RE: Groundwater Focused Feasibility Study
Sauget Area 2 Site - St. Clair County, Illinois

SUBJECT: Sauget Area 2 Superfund Site, Sauget, IL (02-R05-001)
Focused Feasibility Study

Sauget Focused Feasibility Study Review

Re: 1631215032 St. Clair County
Sauget Area 2 Site
Superfund/Technical
Administrative Order by Consent dated November 24, 2000
Focused Feasibility Study/ Groundwater Contamination Near Site R

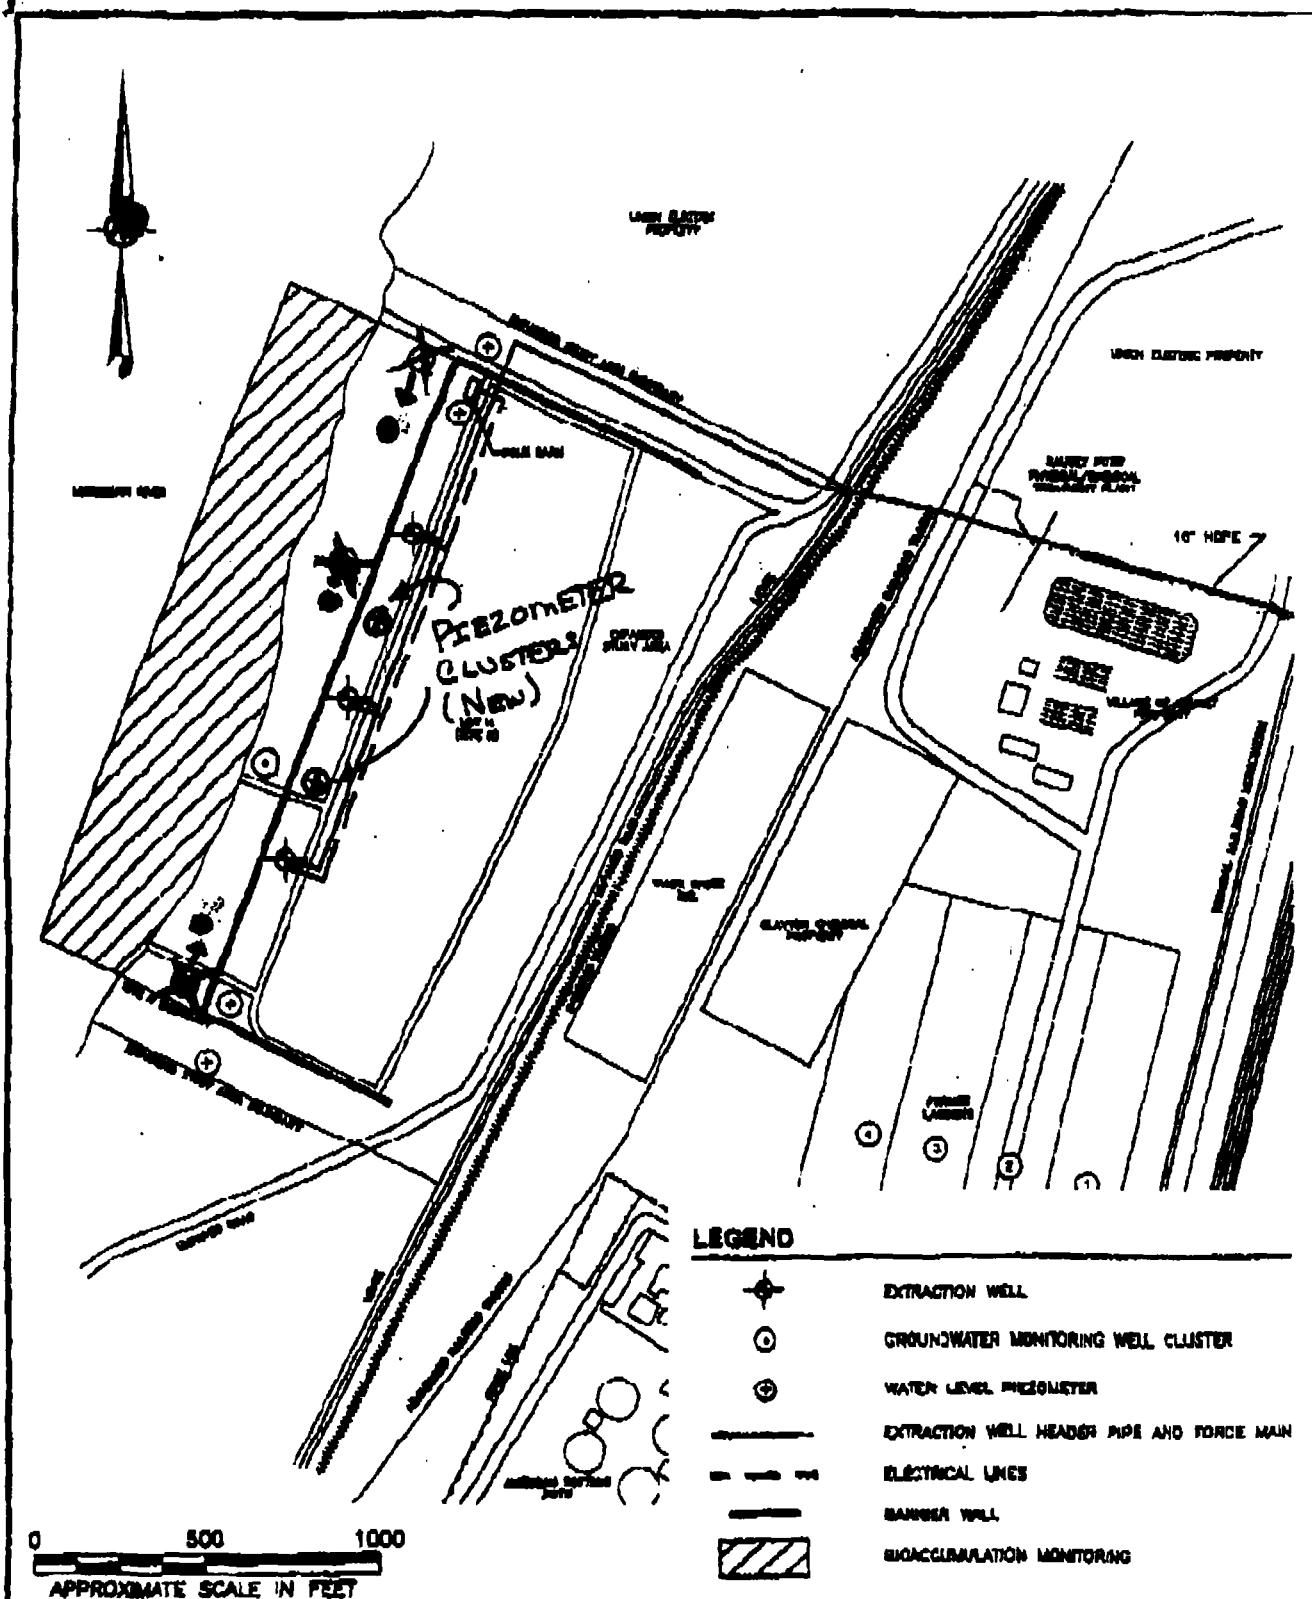
clusters will be installed between the pumping wells and some of the monitoring well clusters will be relocated as shown in Enclosure 4. Solutia has also committed to continue screening for DNAPLs during the installation of the proposed extraction and monitoring wells/piezometers.

A. Currently, ground-water elevations are only measured along the line of extraction wells parallel to the river. It is suggested that additional piezometers screened within each hydrologic unit and located in transects perpendicular to the river near the middle and upgradient limit of the physical barrier be installed. Ground-water elevations from these locations would be used to better define the effects of the containment system on the ground-water flow field in each unit and insure that mounding does not occur, resulting in any significant flow out of the containment cell. Locations along the northern and southern segments of the wall would minimize drilling through landfill materials. It is also noted that several existing wells are located within and near the containment cell. It is recommended that ground-water elevations be monitored in these wells as part of the performance monitoring program. It is also recommended that the

B. With respect to the monitoring of contaminant concentration trends outside the wall, it is recommended that monitoring well clusters be installed north and south of the upgradient portions of the northern and southern wall segments, respectively. Observation of temporal trends in contaminant concentrations in these areas will help assure that ground water from within the cell is not escaping due to mounding. It is also recommended that the spacing between well clusters positioned downgradient of the wall be decreased. An appropriate and practicable spacing may be approximately half of the current spacing. This will aid in identifying significant areas of weakness in the wall and allow a more detailed evaluation of system performance in this critical area. This enhanced network will be most useful during the early phases of performance monitoring. However, once the performance of the system is documented, reduction in the monitoring frequency of many of these wells should be warranted.

p. 5-8. Under "Groundwater Quality Monitoring", the gradient is to be determined by measuring water levels in monitor wells downgradient of Site R and a piezometer cluster on the west side of Route 3. For clarification purposes, Figure 5-1 should be amended to show the location of the piezometer cluster on the west side Route 3.
